DEPARTMENT OF NATURAL RESOURCES
DIVISION OF OIL, GAS AND MINING

March 29, 1999

TO: Pamela Grubaugh-Littig, Permit Coordinator *ggl*
THRU: Daron Haddock, Permit Supervisor *DH*
FROM: Sharon Falvey, Senior Reclamation Specialist *SKF*
RE: Request for Bond Release, Nevada Electric Investment Company, Wellington Preparation Plant, ACT/007/012-BR97, File #2, Carbon County, Utah

Map 2. Alluvium Depth

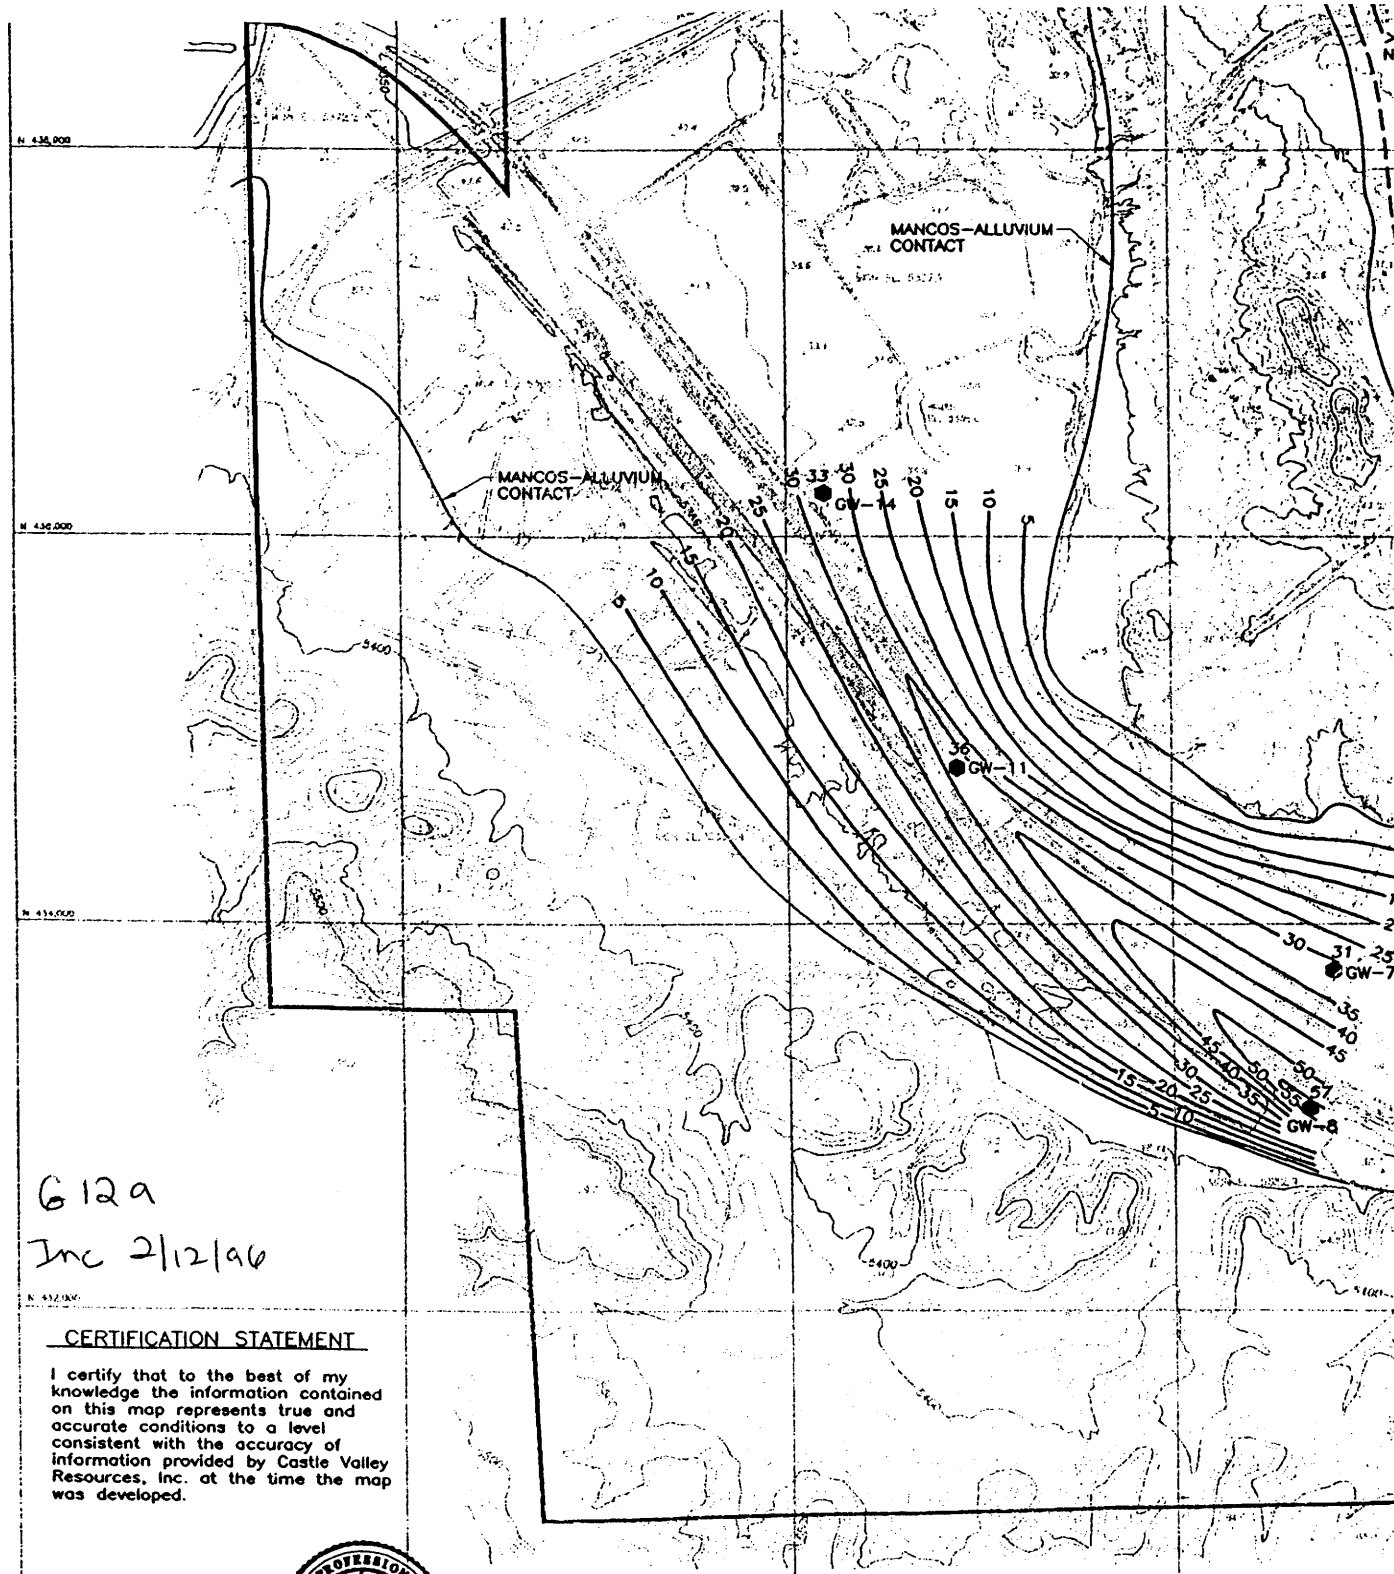
The Cumulative Hydrologic Impact Assessment, August 22, 1984 indicates the water table is generally within 15 feet of the surface in the preparation plant area. Elevations recorded for the preparation plant are summarized in Table 1. The well locations are shown on map 2, Appendix A, copied from the plan.

Figures 1 and 2, Appendix A, graphically present information relative to water elevations through time for the groundwater wells. Alluvium is present in a configuration similar to an abandoned river channel, Map 2 Appendix A (Figure 612 a from the permit). On Map 2, historically used farm lands lie in and adjacent to the Ridge Road and north east of the preparation plant railroad surrounding GW-14. A source of water for the alluvial groundwater system is from the Price River north of the permit area.

The proposed bond release area is associated with ground water monitoring wells: GW - 9, GW - 9B, GW - 10, GW - 11, GW - 12, GW - 13, and GW - 14 (see Map 2). Well GW - 14 is considered mostly out of the range of influence of site operations and is used as a "baseline" well. The operator presented Ground water quality data collected since 1988 in Tables 880.330 - 1 and 880.330 - 2 in Appendix 880.330. The operator has not requested removing these sites from the water monitoring plan, and therefore, proper abandonment will be required and monitoring will be conducted until such time where the applicant applies to remove the wells from the monitoring regimen.

Figure 1

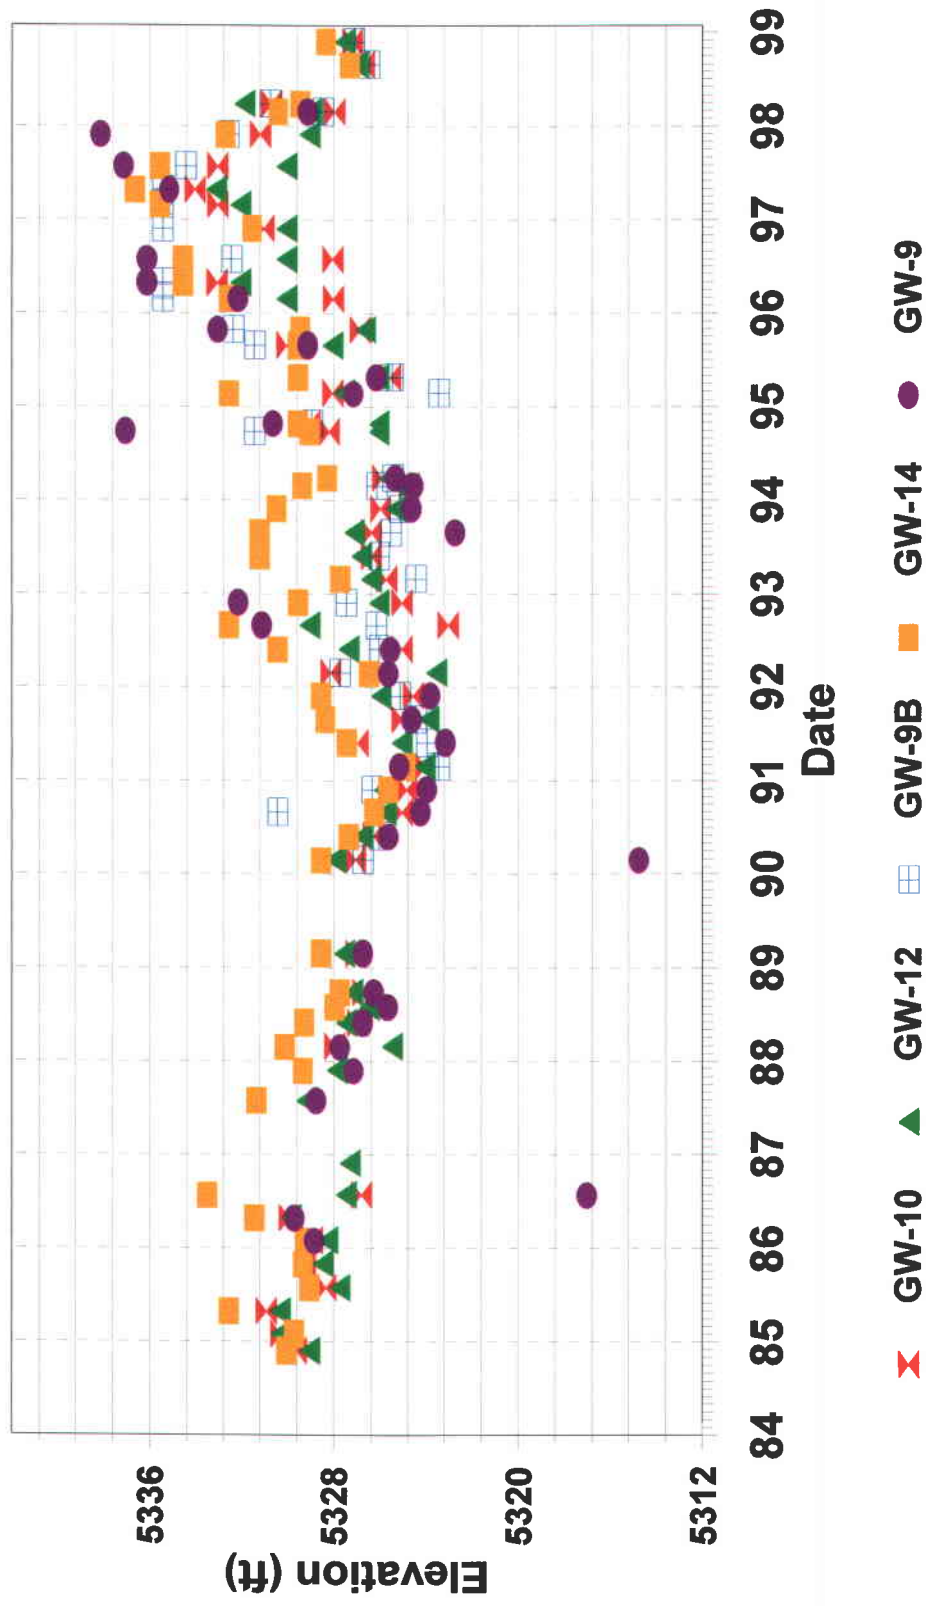
In Figures 1 and 2 it can be observed that the wells in the preparation plant change with seasonal and climatic variation. Higher water levels were observed in March and June for most years except doughty periods. High flows are generally observed in March through June for the Price River below Miller Creek as seen in the MRP, 1972-1986 record, Table 7.28-3C: the

elevated well water levels suggest the river water may influence ground water elevations. Based on the information presented GW-14 is the upgradient ground water level much of the time except for occasional elevated levels at GW-9 and GW-9B. It should also be noted that there have been discrepancies in the data collected for GW-9 and GW-8 which may have resulted from incorrectly identifying the reference elevation (e.g. the ground v.s. collar elevations).

Figure 4

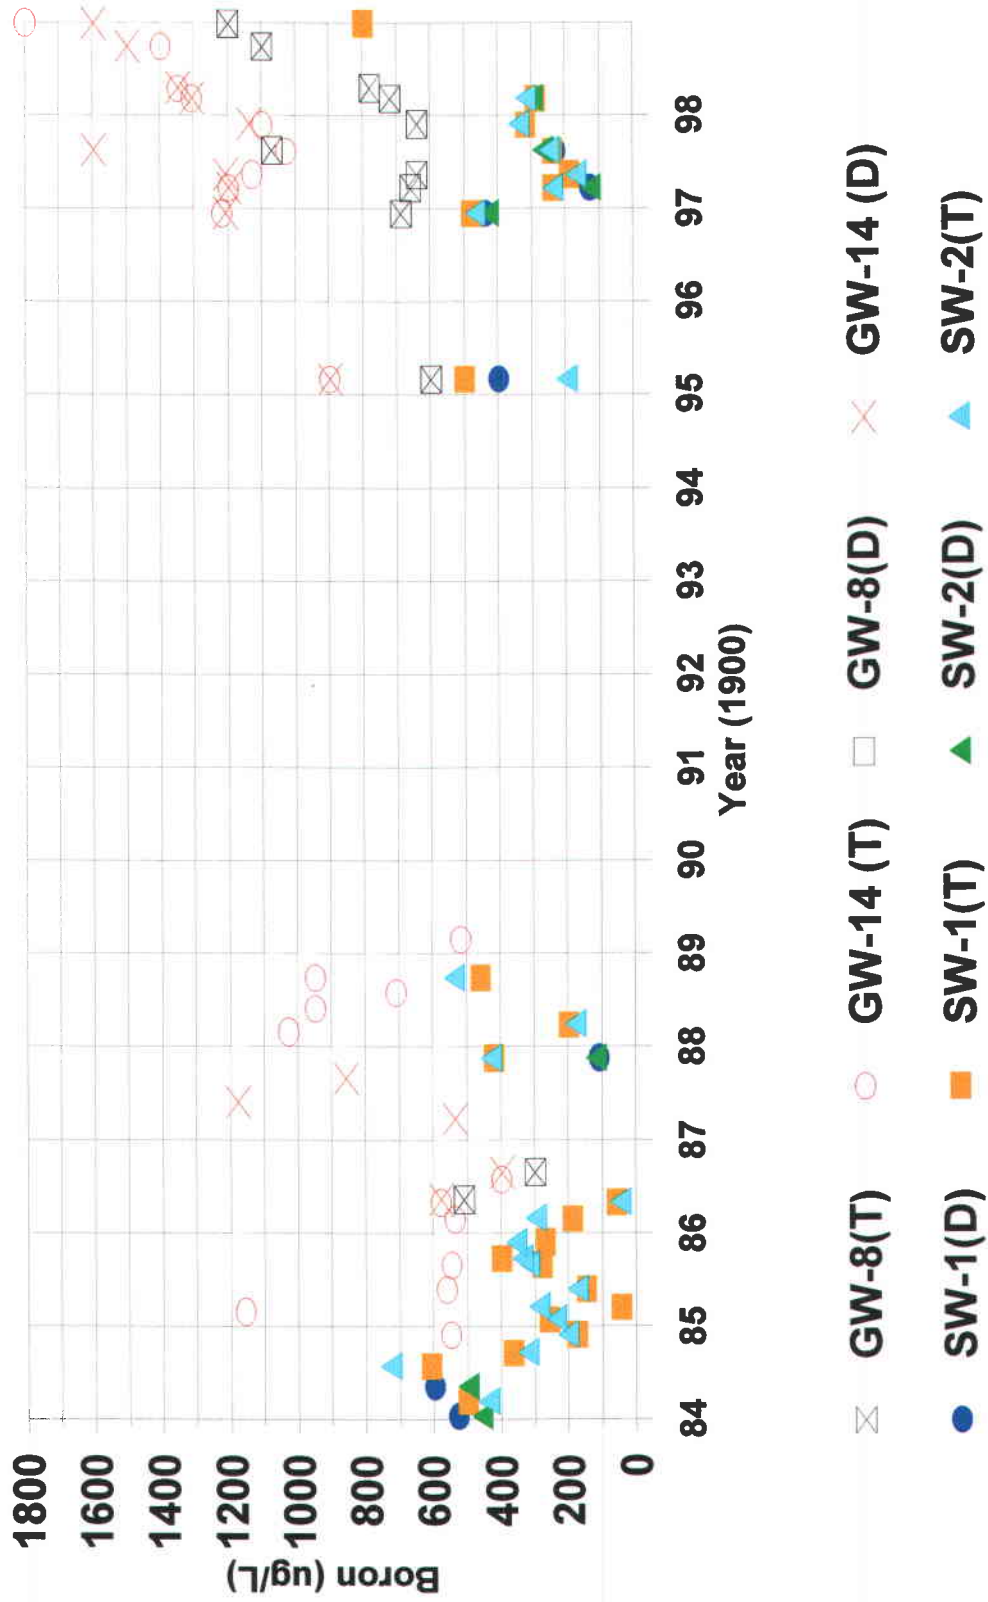
Boron data are summarized for wells in the Preparation Plant area in Table 2. Presently, GW-14 is the upgradient well. Average boron concentrations were highest at this well. Even when the one extreme high value (5170 ug/l) is removed from total boron the average is 952 ug/l. In general, concentrations have increased at each of the sites in the 1996 through 1997 period, and water table elevations have also increased (Figures 1, 2, 3 and 4, Appendix A). It appears the increased concentrations in Boron are related to changes in water table elevations and climatic influences. Although the boron concentrations in well GW-9 is greater than GW-14 in 1997, the concentration has generally been lower than concentrations recorded at GW-14. Concentrations through time are shown for Wells GW-14, GW-13 GW-12 and GW-9 for dissolved boron in Figure 3. This graph illustrates the general pattern for total and dissolved boron between GW-14 and wells surrounding the preparation plant. Even though elevated boron levels remain in the coal waste in the proposed bond release area may increase the boron concentration in the groundwater. The data does not indicate this level will be greater than well GW-14 which is often upgradient. Furthermore, the surface water sites have not exceed standards for boron in irrigation water, Figure 4.
